**TELEDYNE CONTINENTAL® AIRCRAFT ENGINE
CRITICAL SERVICE BULLETIN
Compliance Necessary To Maintain Safety**

CSB97-9

SUBJECT: GTSIO-520 CRANKCASE INSPECTION

PURPOSE: PROVIDES INSTRUCTIONS FOR CRANKCASE INSPECTION AND REMOVAL OF NUMBER 5 CYLINDER 7TH STUD RETAINING BRACKET

Figure 1

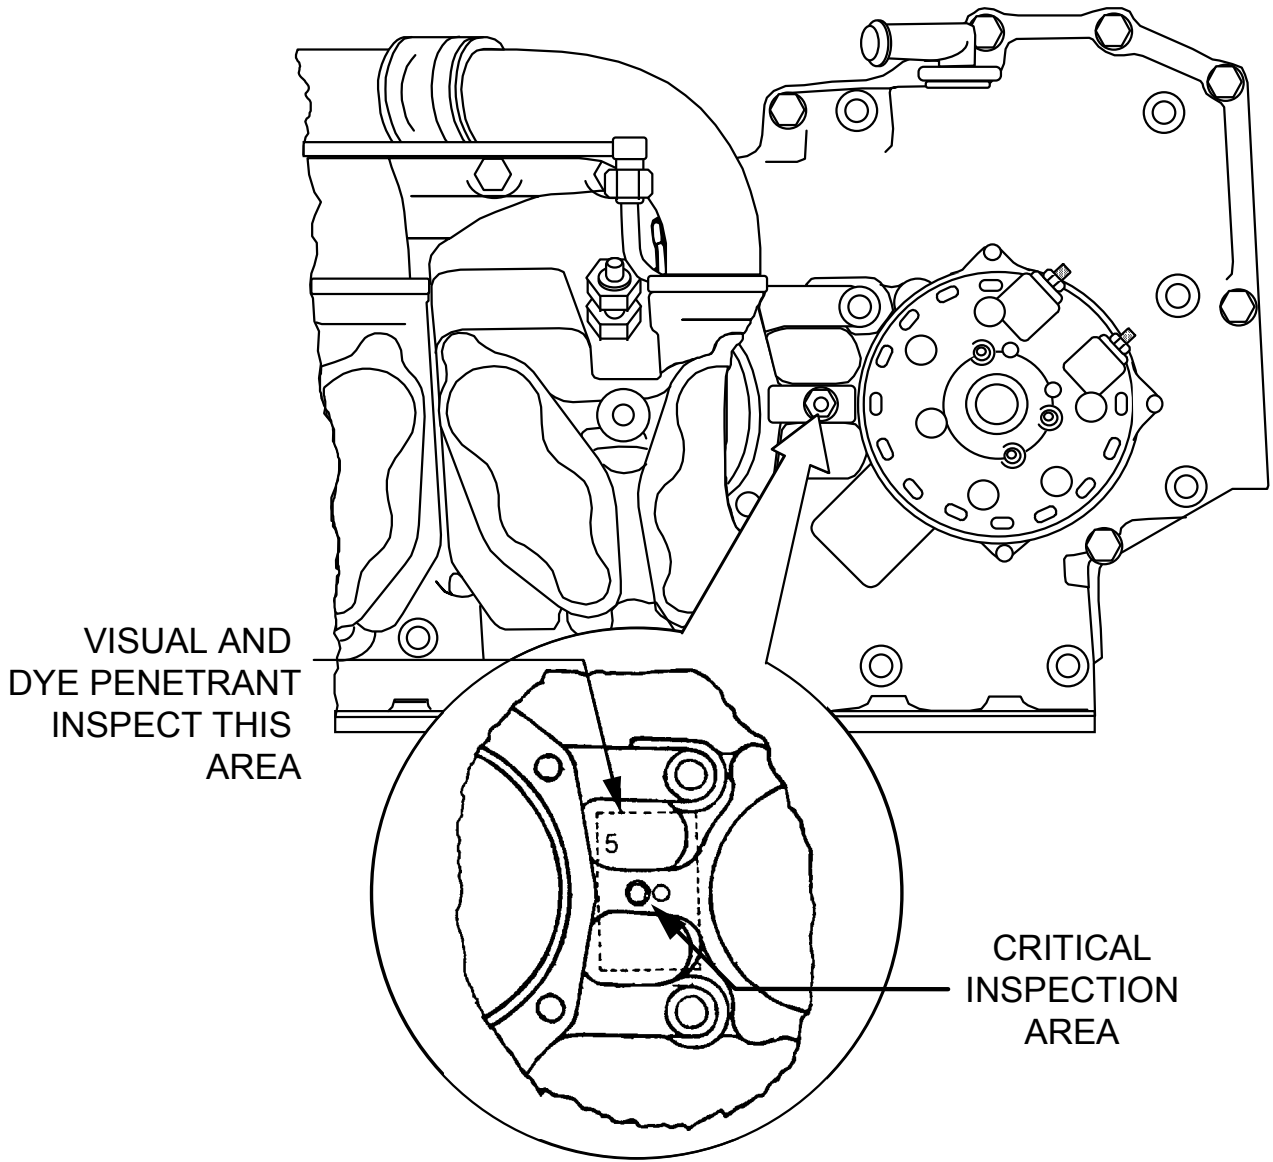
Inspection of engines and crankcases returned to TCM has identified the possibility of a crankcase crack developing in the area of the number 5 cylinder 7th stud and aft (9 o'clock) alternator mounting stud.

Within the next 25 operating hours after the effective date of this bulletin and every 50 hours for the next 500 hours of operation perform a visual and dye penetrant inspection of the engine crankcase at the number 5 cylinder 7th stud location. Refer to Figure 1 for area to be inspected.

1. Clean the area around and adjacent to the number 5 cylinder 7th stud and alternator (Refer to Figure 1) with an approved cleaner.
2. Perform a visual and dye penetrant inspection of the area, with specific attention to the area between the number 5 cylinder 7th stud and the aft (9 o'clock) alternator mount stud (Refer to Figure 1).

3. If a crack is identified, the crankcase or engine must be replaced prior to further operation.
4. If no crack is identified, comply with the following instruction prior to returning the engine to service.
